# SYDNEY WESTERN CITY PLANNING PANEL

## COUNCIL ASSESSMENT REPORT

<b>Panel Reference</b>	PPSSWC-319
<b>DA Number</b>	DA-19/2023
<b>Local Government Area</b>	Liverpool City Council
<b>Proposed Development</b>	Demolition of existing structures and construction of a three-storey centre-based child care facility over basement car parking accommodating 124 children
<b>Street Address</b>	Lots 1 & 2 in DP 1058859 73 Lachlan Street, Warwick Farm
<b>Applicant</b>	FLDC Pty Ltd
<b>Owner</b>	Ben Nicholas Clint Biggs Robert Noyes
<b>Date of DA Lodgement</b>	11 January 2023
<b>Application Type</b>	Development Application
<b>Capital Investment Value (CIV)</b>	\$5,500,000 (including GST)
<b>Regionally Significant Development Criteria</b>	Clause 5, Schedule 6 of State Environmental Planning Policy (Planning Systems) 2021: Private Infrastructure and community facilities over \$5 million
<b>Key Planning Instruments</b>	<ul style="list-style-type: none"><li>• Education and Care National Regulations</li><li>• State Environmental Planning Policy (Resilience and Hazards) 2021</li><li>• State Environmental Planning Policy (Biodiversity and Conservation) 2021</li><li>• State Environmental Planning Policy

**Figure 6:** Elevations (Source – FLDC Architects: 2023)

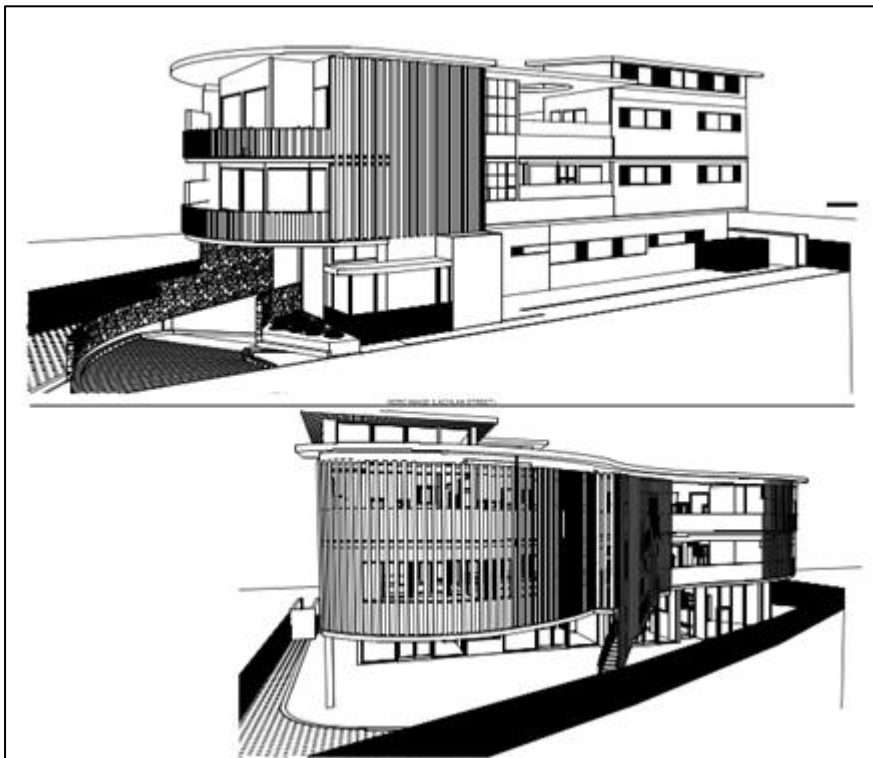
2. **Building Separation** – Clause 7.4 (2)(a) of the Liverpool LEP 2008 requires a building separation of 9 metres for buildings exceeding a height of 12 metres. A separation of only 5 metres to the eastern-adjoint building has been provided. A Clause 4.6 variation request has not been provided to assess the variation.

4. **Front and Rear Setbacks** – The proposal does not comply with the required setbacks to both Sydney Road (Hume Highway) and Lachlan Street. The required setback to Sydney Road is an 8m landscaped setback, however, the proposal provides a setback ranging from 1.3m to 4.7m. The required setback to Lachlan Street is a 4.5m landscaped setback, however, the proposal provides a setback ranging from 1.2m to 6m.

5. **Side Setbacks** – Whilst a 3m side setback to the eastern boundary might be considered appropriate having regard to ADG building separation and solar access requirements, it is noted that Cl. 7.4 of the LLEP 2008 requires a 9m separation between buildings.

The proposal also includes a fire stair with a zero setback to the eastern boundary. An easement for maintenance purposes would need to be created in this instance, which would require the consent of the neighbouring property owner.

8. **Acoustic Barrier** – The accompanying acoustic report recommends the erection of a 2.1m high continuous barrier along the boundary to Sydney Road (Hume Highway), which would present poorly to this main road.
